# **ACER Decision on the ERAA 2021: Annex I**

**DECISION No 02/2022**  
**OF THE EUROPEAN UNION AGENCY**  
**FOR THE COOPERATION OF ENERGY REGULATORS**  
**on the European Resource Adequacy Assessment for 2021**  
**Technical annex**

**22 February 2022**

Figure 14: Reserve requirement as added load compared to average peak and off-peak demand (2025 assumptions)

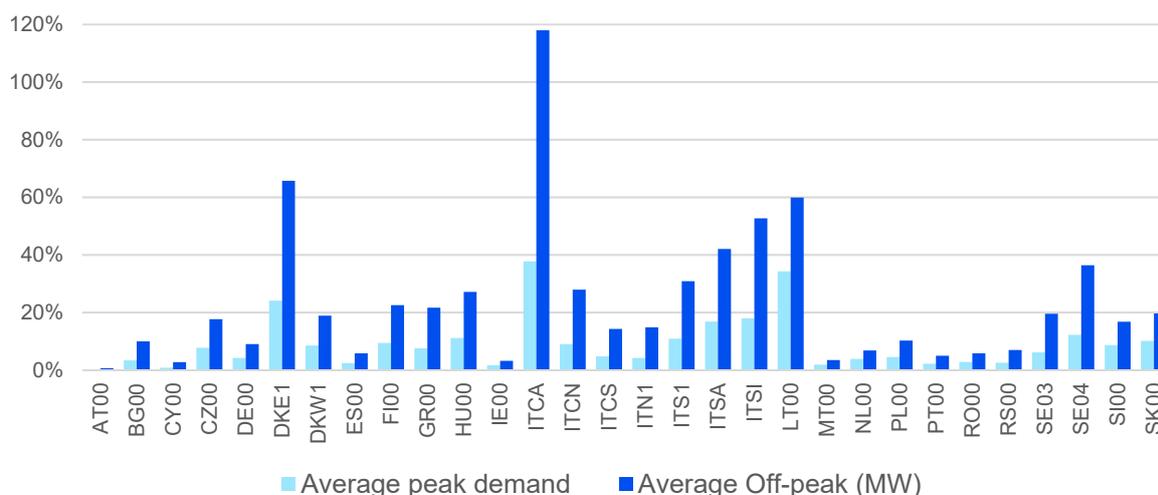
- On the one hand, it can affect market prices in the economic dispatch modelling. In general, this simplification is expected to drive prices up. By adding load, the optimization algorithm will possibly clear at a higher value than if the reserve requirement was treated outside the energy market. Particularly, this would be the case if the resources serving as balancing reserves were high in the merit order, i.e. have a high short-run marginal cost. ACER expects this approach to affect prices depending on the relative size of the added load in relation to the demand levels; the higher the relative size of the added load, the greater the potential impact on prices. Figure 14 shows the added load, due to the reserve requirement, as a share of the average peak and off-peak demand across all climate years. The added load is particularly prominent in smaller bidding zones, compared to larger ones.

Due to the indirect, complex and contrary effects of the current approach to reflect the reserve requirements as added load, it is difficult to assess its impacts on the risks to resource adequacy.

While the current approach is in line with the ERAA methodology, ACER believes it unnecessarily distorts the results of the assessment. Therefore, ACER recommends that future assessments treat balancing reserves outside the economic dispatch, or in other words the assessment allocates the reserve requirement to specific capacities and does not treat it as added load (high priority). Such an approach would effectively imply that such resources would make sufficient revenues to be economically viable.<sup>95</sup>

Figure 15 Number of different Fmax values on considered CNECs

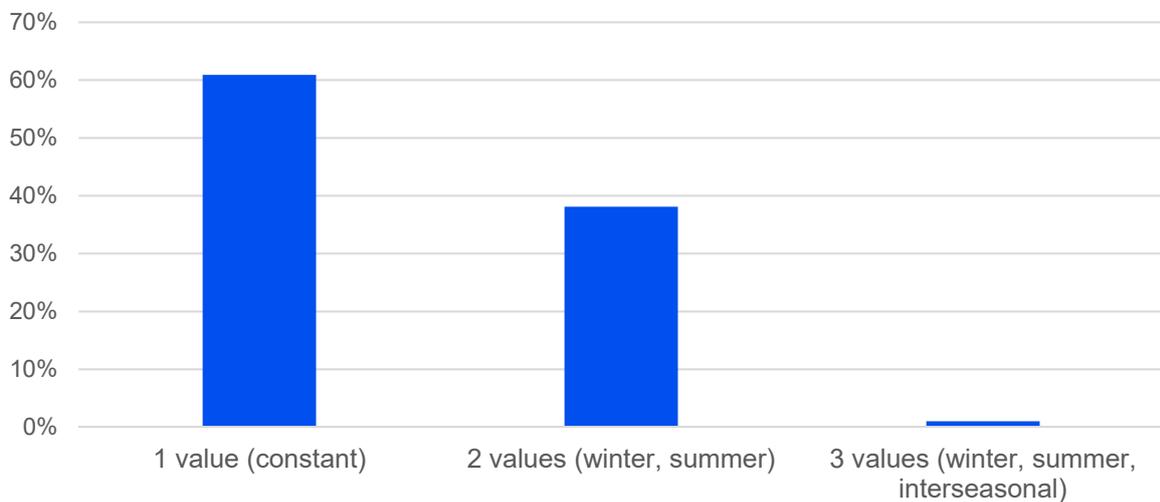
Figure 15 shows, for all considered CNECs, the number of different Fmax values used for the full year. Despite the ERAA methodology requiring at least seasonal calculation of cross-zonal capacities,<sup>110</sup> only one Fmax value applied for most CNECs. Some CNECs applied two values per year, while only 1% of CNECs also defined an “interseasonal” value.

Regarding the fourth step, associated with the estimation of RAM, ACER expects ENTSO-E to at least introduce seasonal Fmax values on all CNECs, which change Fmax between seasons (high priority), and to consider reflecting more detailed variations of Fmax, e.g. when dynamic line rating is expected to apply (low priority). ACER also expects ENTSO-E to provide appropriate data to enable oversight of the RAM estimates (high priority).
